Subject: Transmittal Letter – Errata and Addenda for Revision 1 of the April 2013 Mt. Taylor Mine Closeout Closure Plan and Revision 1 of the Application for Revision of Mine Permit to Active Status

ADDENDUM #1

APPLICATION FOR REVISION OF MINE PERMIT #C1002RE FROM STANDBY TO ACTIVE STATUS AND MODIFICATION OF GROUND WATER DISCHARGE PERMIT DP-61, MT. TAYLOR MINE, SAN MATEO, NEW MEXICO

**APPLICATION FOR REVISION OF MINE PERMIT #C1002RE FROM STANDBY TO
ACTIVE STATUS; MODIFICATION OF GROUND WATER DISCHARGE PERMIT DP-
61, MT. TAYLOR MINE, SAN MATEO, NEW MEXICO, REV.1, NOVEMBER 2013;
and**

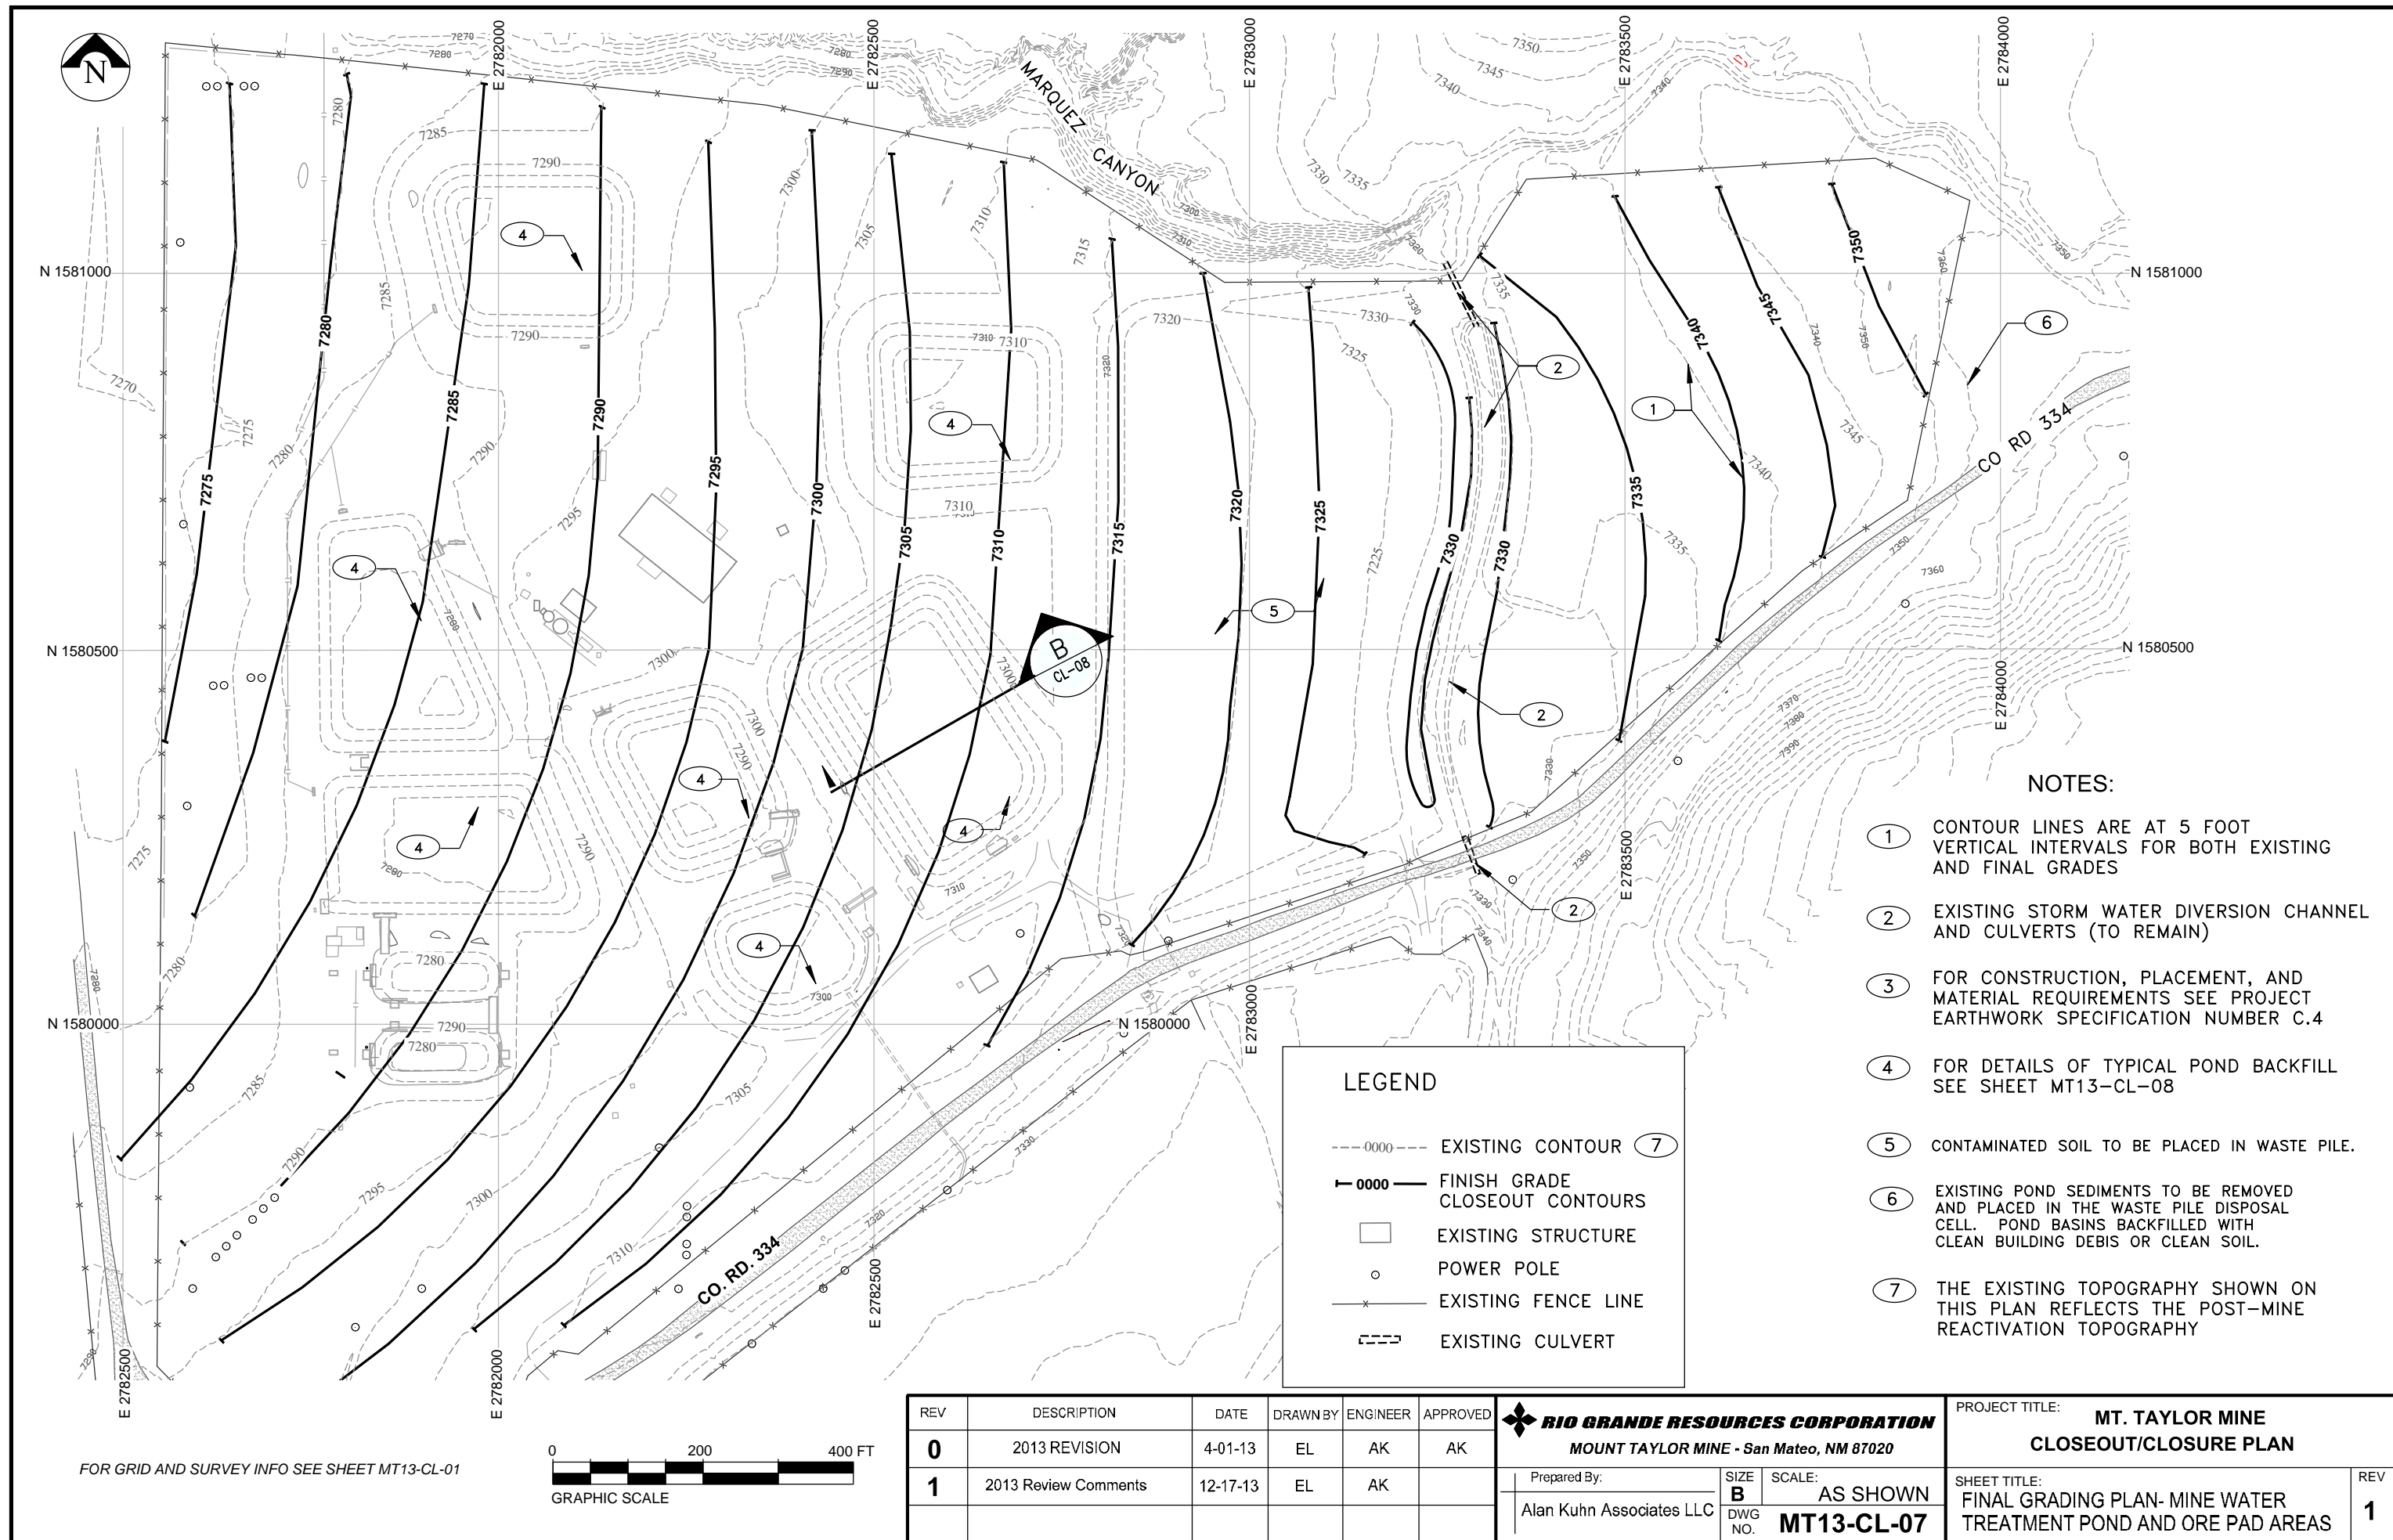
Drawing MT13-CL-07

The coordinate labels have been corrected. See the correct Drawing MT13-CL-07b.
